Attachment 5 – Stormwater and Flooding Response

5001_23_03_03_council rfi response_rev2.docx

**RE: EAC MASTERPLAN DA2022/75
EMMANUEL ANGLICAN COLLEGE
LOT 1 DP 1278708, 62 HORIZON DRIVE, WEST BALLINA.**

Ardill Payne & Partners (APP) has reviewed Council's Request for Additional information dated 20 September 2022 as well as subsequent meeting (6 October 2022) and email correspondence in relation to this RFI. Please find below a summary of the sites stormwater history as well as responses to items 5-9 of Councils RFI. The RFI items have been copied below in italics for ease of review.

Historical site catchments and Wider Area Elevation Sketch

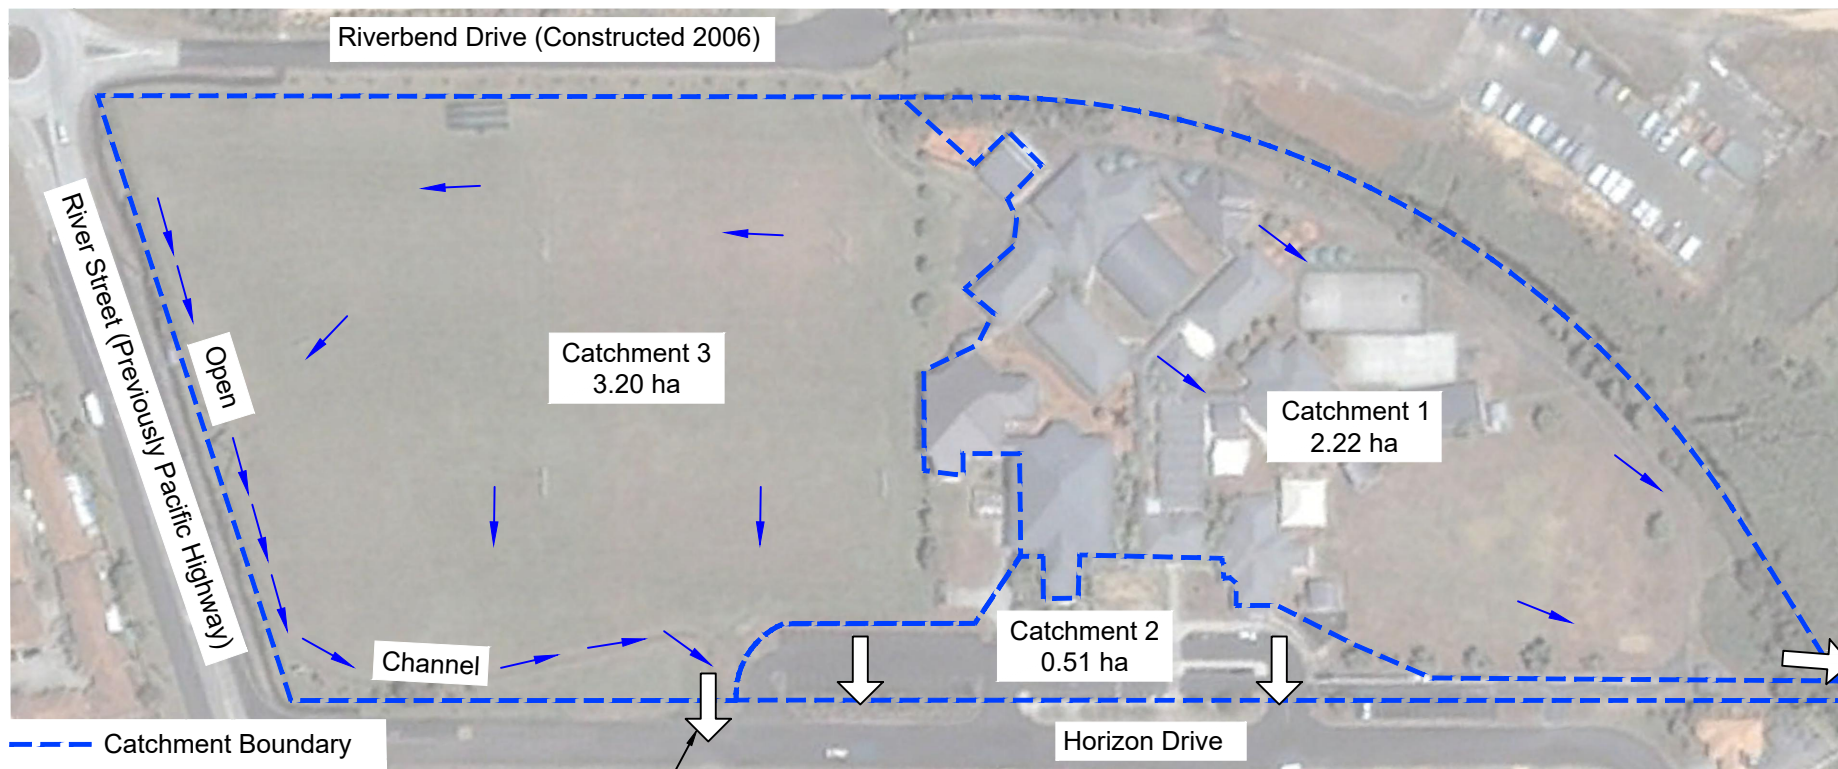
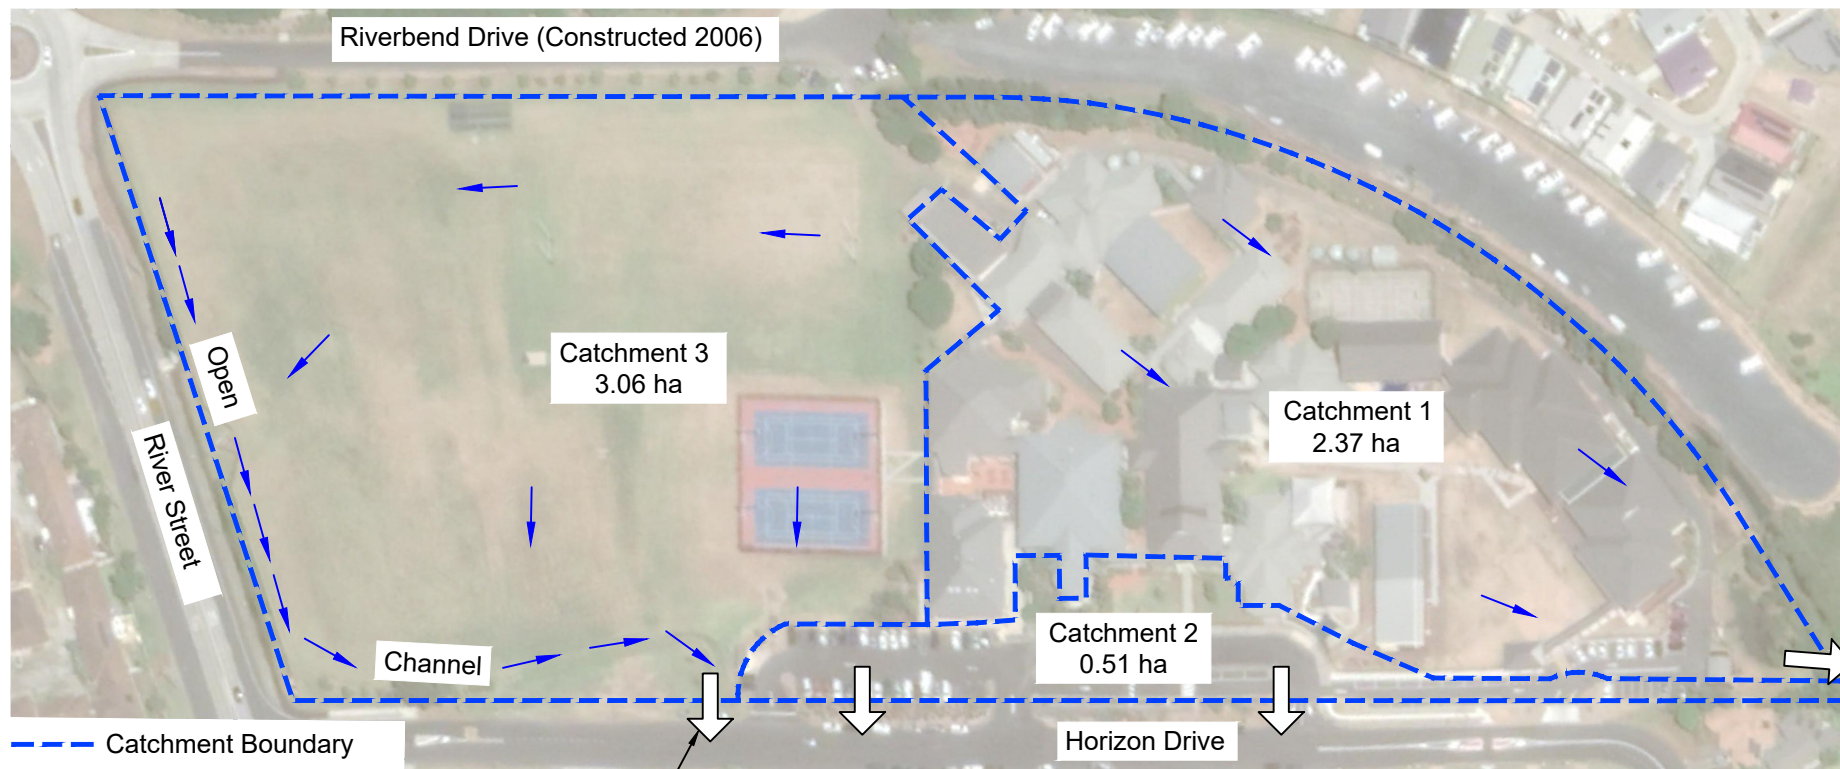
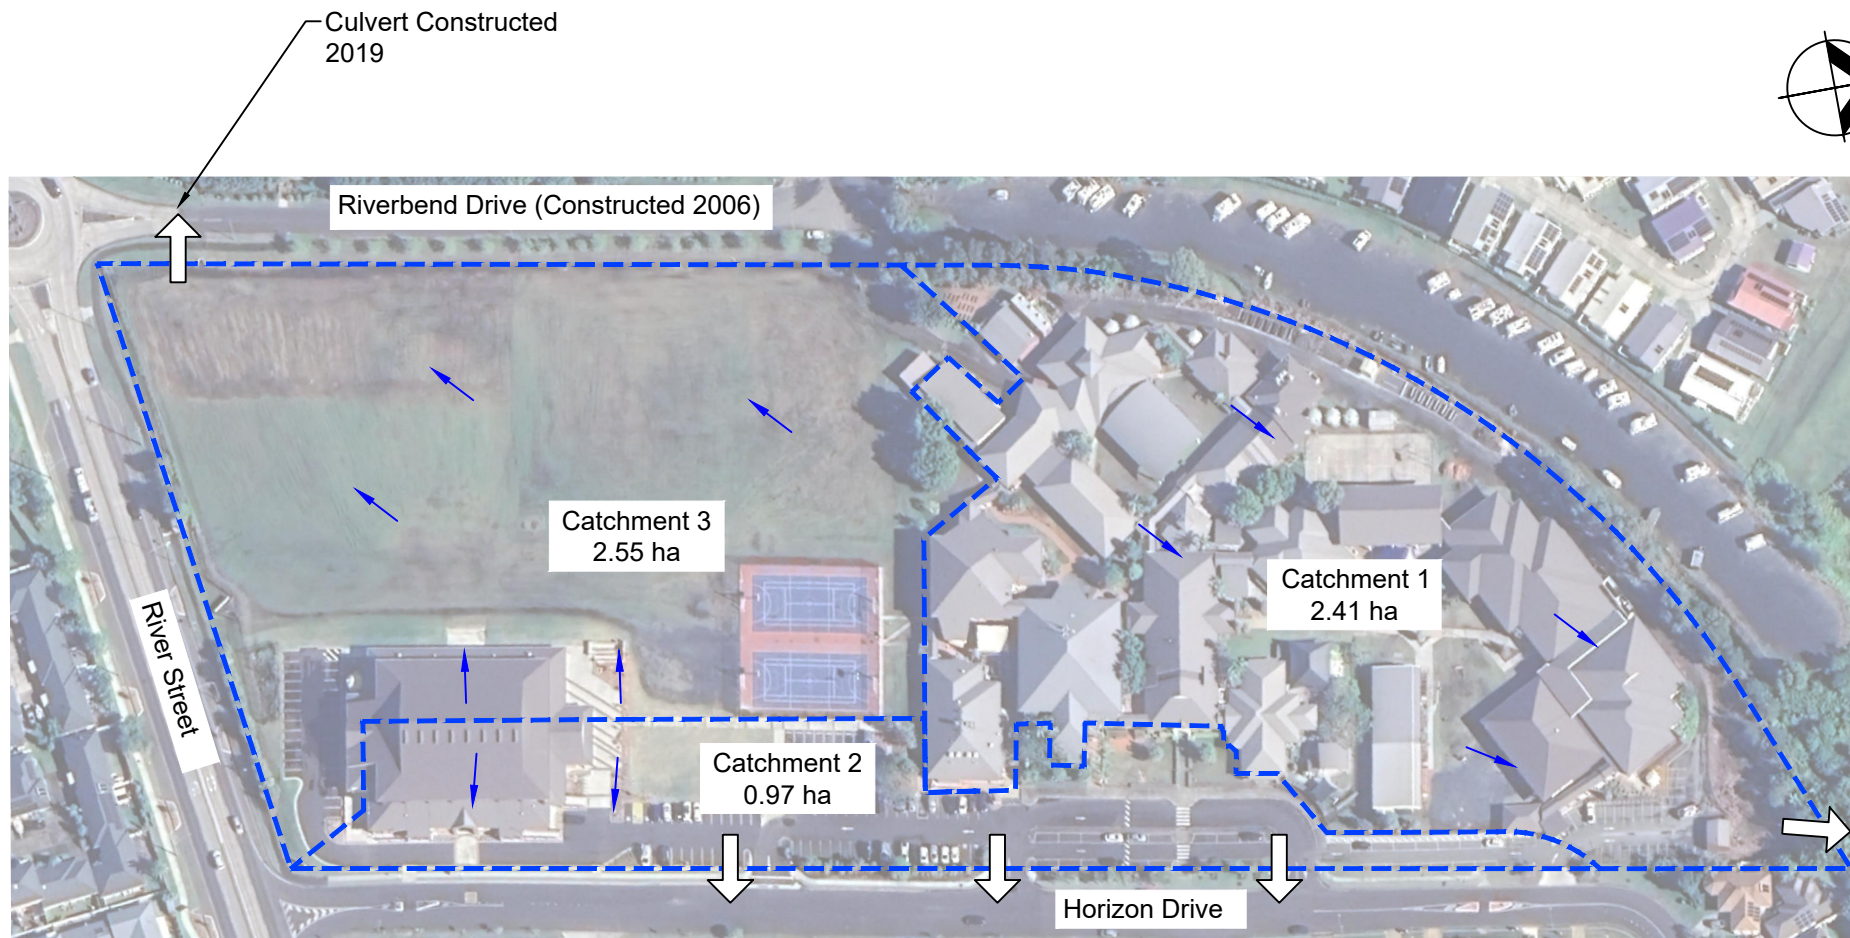
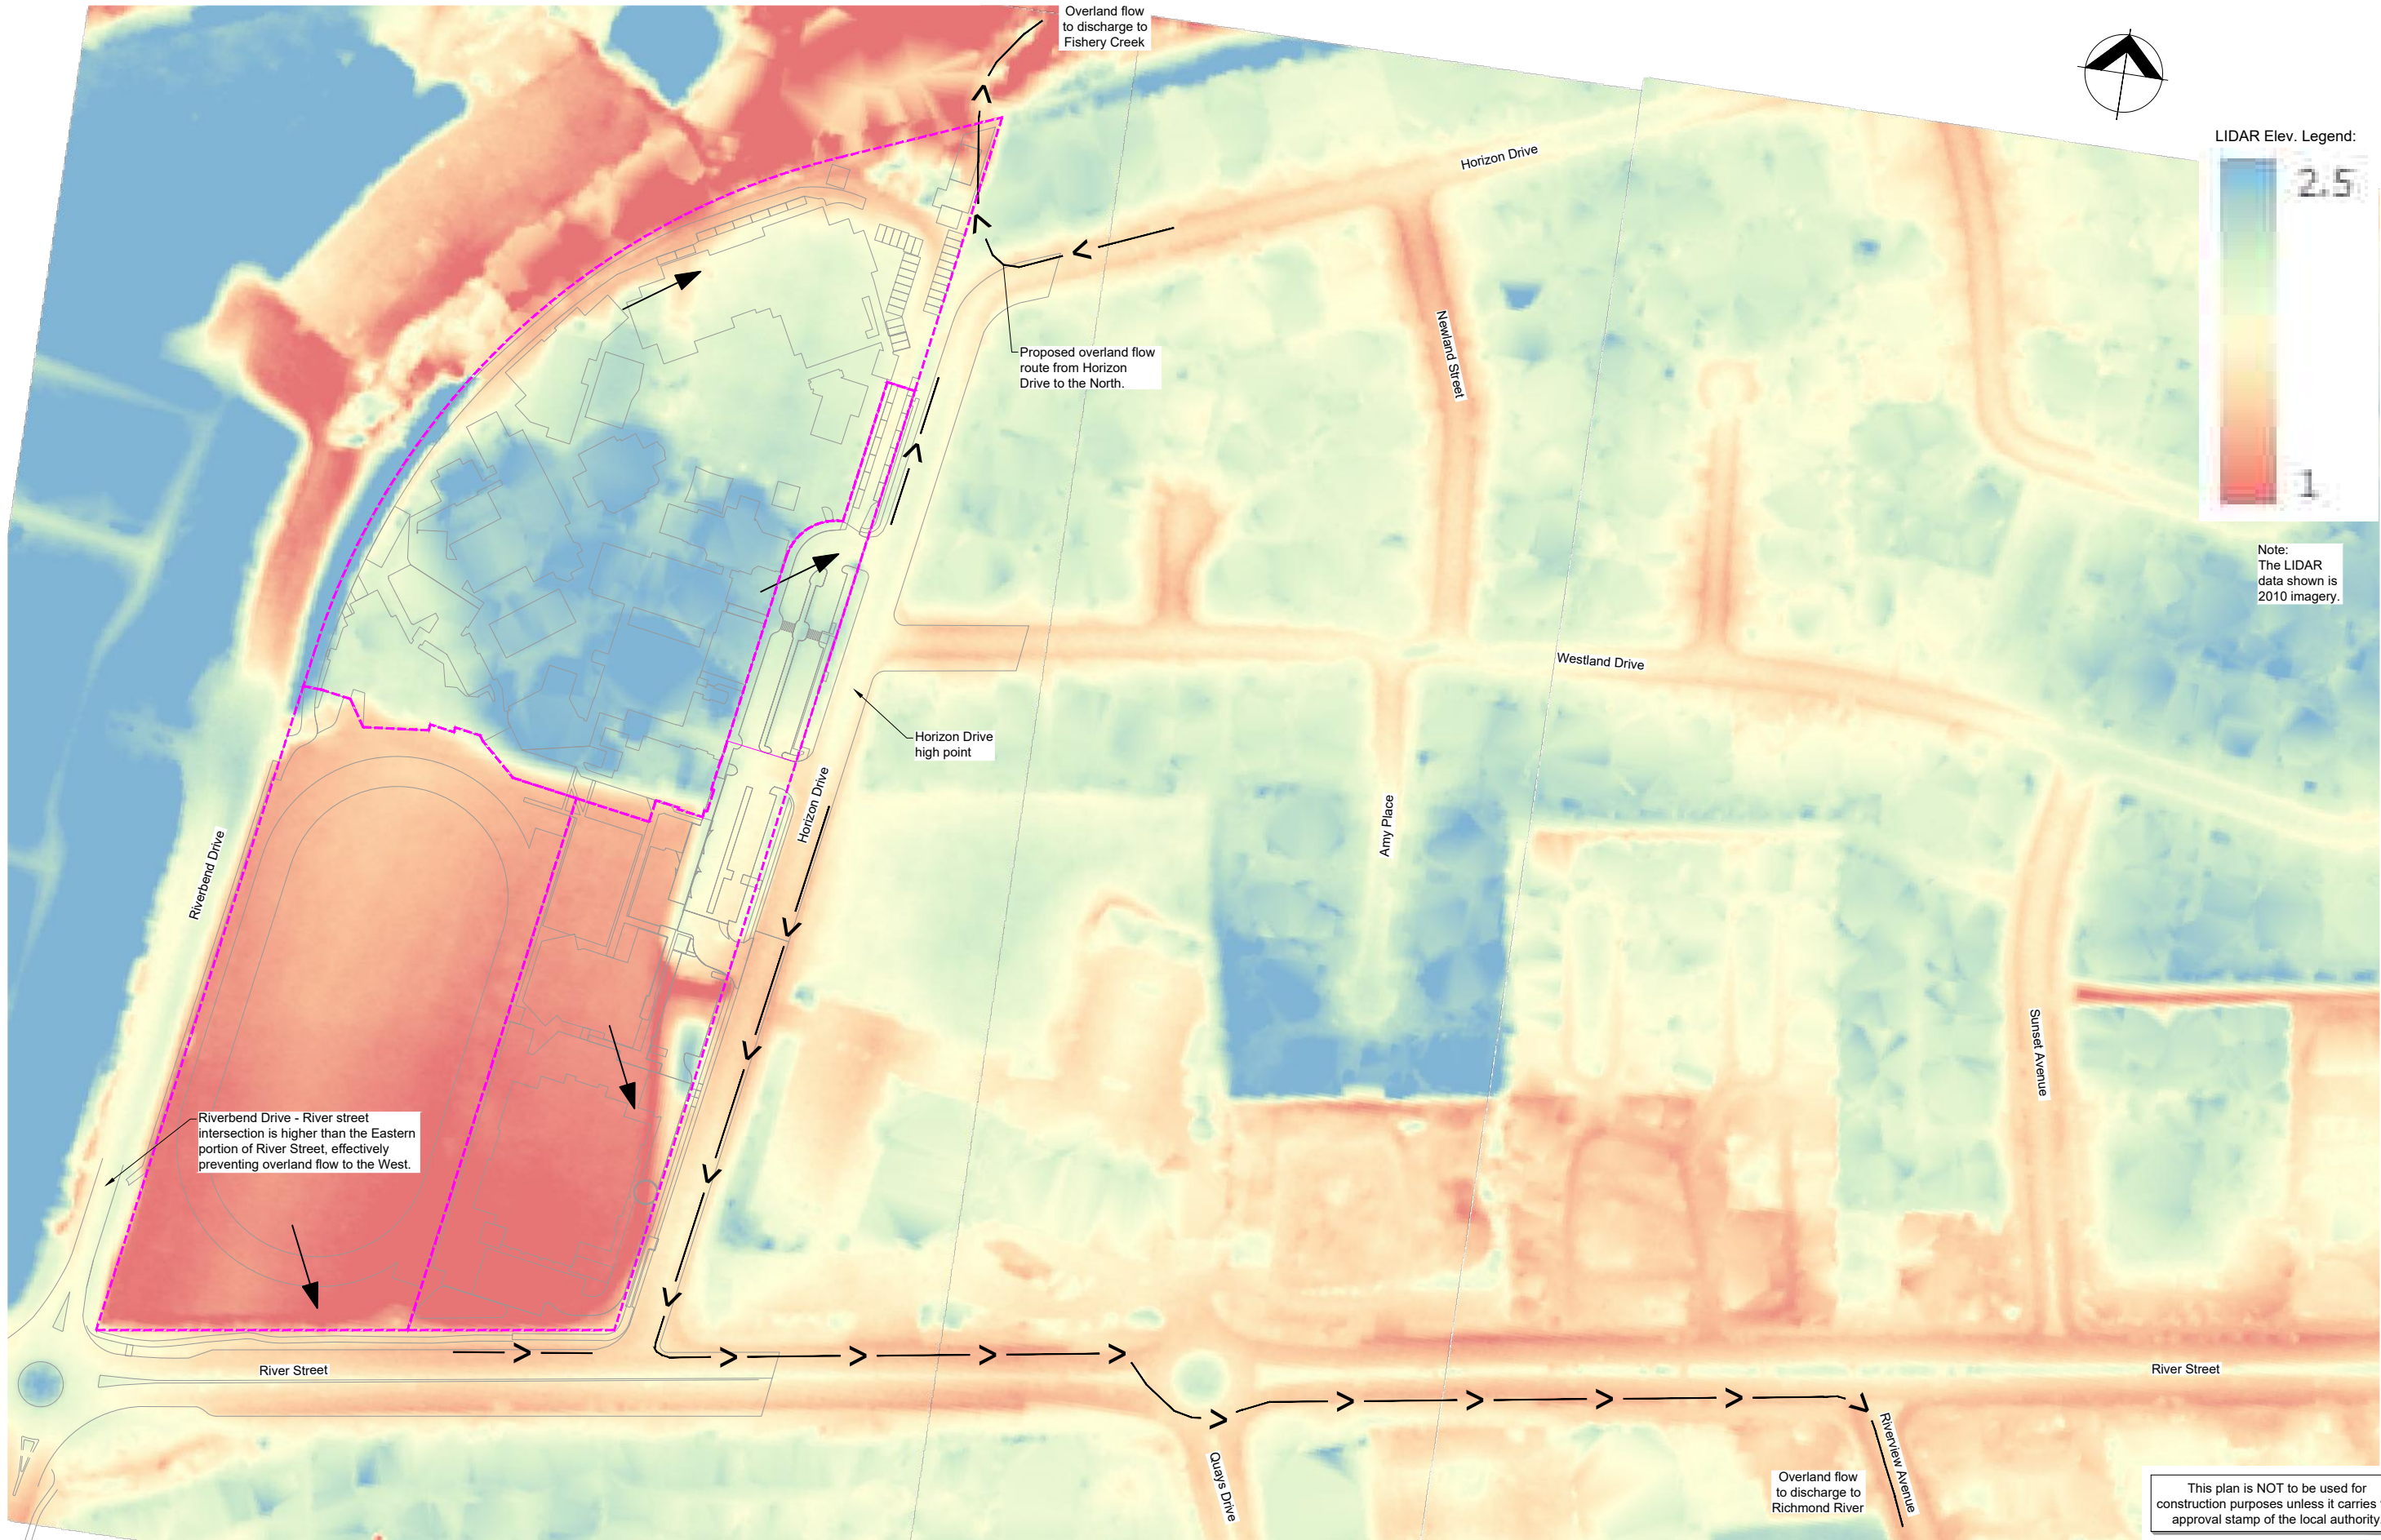
- *Internal catchments, details of internal conveyance infrastructure (plan locations, sizes, grades, invert levels, flow capacities) flow rates in design events in both piped systems and overland flow paths.*
- *The legal points of discharge.*
- *Analysis of external conveyance infrastructure that demonstrates there is sufficient spare capacity available to accommodate runoff from the school; from the school boundary to the ultimate discharge points at Fishery Creek (east of Barlows Road) and Emigrant Creek (south of River Street).*

The college has effectively had 3 catchments since its inception. There have been minor changes to the catchment boundaries over the College's development. More significantly there have been changes to discharge points of these catchments as discussed below. Plans showing the catchment boundaries and discharge points for major flows at various periods of times have been enclosed as Appendix A. The various time periods are further discussed below.

Pre 1999 – The college site was undeveloped and the surrounding housing estate was in place. Council asset stormwater drainage had been installed with discharge of the drainage line extending north through 54 Horizon Drive (SP 69608) and discharging to open drains within Lot 137 DP 858896 and Lot 2 DP500372. These open drains outfall to Fishery Creek to the north east. To the south of the site an open drain running parallel with the River Street (formally Pacific Highway) flowed west with outfall to

1999-2000 – the college site commenced development with filling of the northern portion of the site and construction of the first stage of buildings being completed. At this time, the three primary catchments for the site were defined. Catchment 1 consists of the partially filled northern portion of the site which discharged to the north in accordance with Councils directions through the initial development approval process. This catchment discharges via a detention basin constructed in the north eastern corner. This basin was designed to accommodate the completed initial masterplan at the time of its construction. Catchment 2 consists of a small portion in the east of the site. This catchment effectively runs from the eastern boundary across the parking, pickup and set down area. This catchment discharges to Horizon Drive. Catchment 3 is the southern portion of the site, at this period of time this catchment discharged to the south west via the open drain along River Street.

2005/2006 – during this period the catchment boundaries were still effectively unchanged. Outside of the site the neighbouring Riverbend development as well as Riverbend Drive and roundabout with River Street (then Pacific Highway) was under construction. During this period a major change to the discharge point of Catchment 3 occurred. As part of the Riverbend Drive construction the open drain which was the primary drainage point for Catchment 3 was filled and no culvert provision below Riverbend Drive to drain the southern portion of the site was provided. Due to this blocking of the natural drainage point of this catchment the school was directed by Council to discharge Catchment 3 to the existing piped network within Horizon Drive. This change to the discharge point of Catchment 3 effectively increased the Colleges catchment discharging to this network over seven fold.

2006-2019/2020 – During this period the Colleges catchments and discharge locations effectively remained constant post Riverbend construction. Additional buildings were constructed within Catchment 1, the later buildings in the far north having onsite detention tanks to attenuate flows from the additional roof area despite the original detention basin being sized to accommodate them.

2019 – 2022 – During the construction of the recent Multi-Purpose Hall approval was sought and achieved to reinstate a drainage discharge under Riverbend Drive to the then open drain running west along River Street. Subsequently the Council completed the River Street duplication through this portion and piped the open drain further to the west. The construction of the Multi-Purpose Hall and

In addition to the above, following our meeting on the 6 October, it was agreed that review of overland flow routes for runoff which exceeds the capacity of the piped network system intended to convey minor events as this is the portion of stormwater which potentially effects neighbouring properties and the wider community.

This review of the wider area utilised NSW Government Spatial Services Light Detection and Ranging (LiDAR) data, Council infrastructure GIS, available field survey, site inspections and local knowledge. Based on this review three primary overland flow routes have been identified which would discharge excess flows from the site. A summary sketch '5001-SK05 Overland Flow Path on LiDAR Elevations' has been prepared showing coloured elevation bandings between RL1.0m AHD (red) to 2.5m AHD (blue). Areas of elevation above or below this banding extents is displayed as the solid colour.

1. Through the north eastern corner to Fishery Creek via open drainage north of Horizon Drive (northern portion of site)
2. To River Street running east and down Riverview Avenue (southern portion of site)

There exists a high point in Horizon Drive at 55 Horizon Drive which prevents water traveling north or east into Westland Drive up to approximately 1.60-1.65m AHD. This highpoint separates overflow routes 1 and 2. The local high point within River Street is approximately 1.5m AHD which would allow overland flow to preferentially travel east along River Street rather than North along Horizon Drive.
